**From:** Oswald Jr, Woodin  
**Sent:** Thursday, February 27, 2025 1:44 PM  
**To:** DRS  
**Subject:** Trench Data\_3455 Jennings Chapel Road  
**Attachments:** Site Visit Notes\_3455 Jennings Chapel Road.pdf

**From:** Oswald Jr, Woodin  
**Sent:** Monday, March 3, 2025 11:25 AM  
**To:** Jon Weaver  
**Cc:** DRS  
**Subject:** FW: Trench Data\_3455 Jennings Chapel Road  
**Attachments:** Site Visit Notes\_3455 Jennings Chapel Road.pdf; Perc Cert Plan Review Comments\_3455 Jennings Chapel Road.pdf

**From:** Oswald Jr, Woodin  
**Sent:** Thursday, February 13, 2025 11:43 AM  
**To:** DRS  
**Subject:** Perc Cert Plan Review Comments\_3455 Jennings Chapel Road  
**Attachments:** septic specs\_250213\_081346.pdf

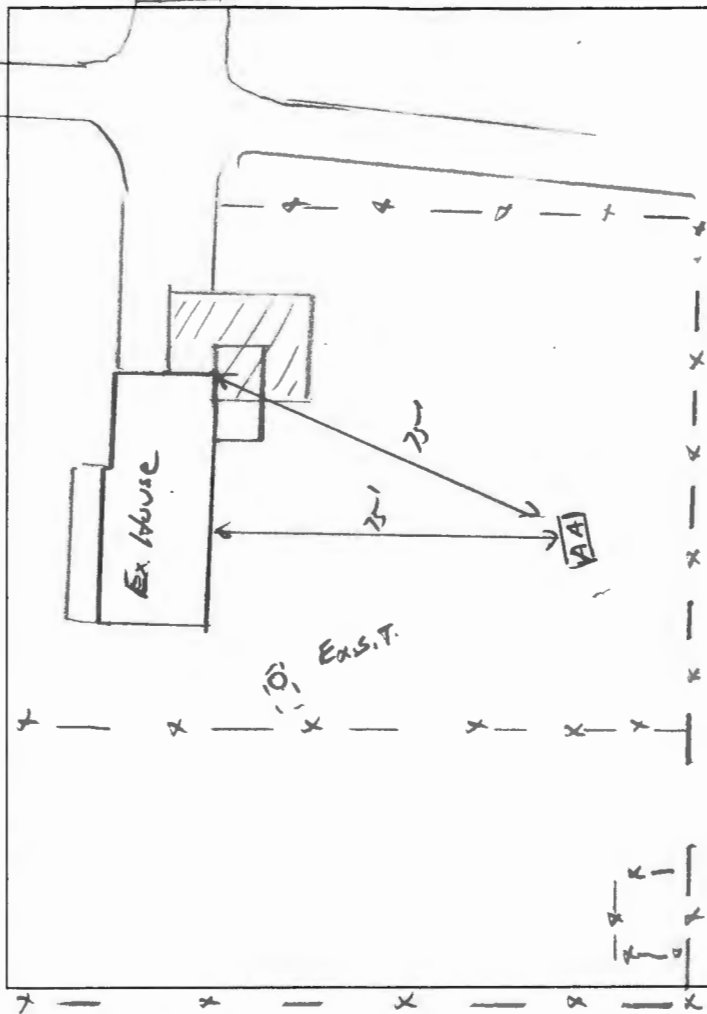
Both the water and electrical lines must be abandoned and removed from the proposed SDA prior to signature of the perc cert plan. We also need documentation regarding the size and condition of the septic tank. Additionally, please plot perc test holes# AA on the plan (See attached sheet for location of test hole). Lastly based on Kevins site visit notes, the ***trench data / calculations*** are as follow:

Upper Trench = 24'L, Inlet at 4', 3'W, 11'D

Lower Trench = 31' L, Inlet at 4', 3'W, 11'D

55 LF of trench x 3'W = 165 sq. ft. / 0.3125 = 528 x 1.2 (rate) = 633 gallons per day / 150 = **4 bedrooms**

Sidewall Redcution Credit =  $w+2/w+1+2 (d) = 3 + 2/3+1+2(6) = 5/16 = 0.3125$
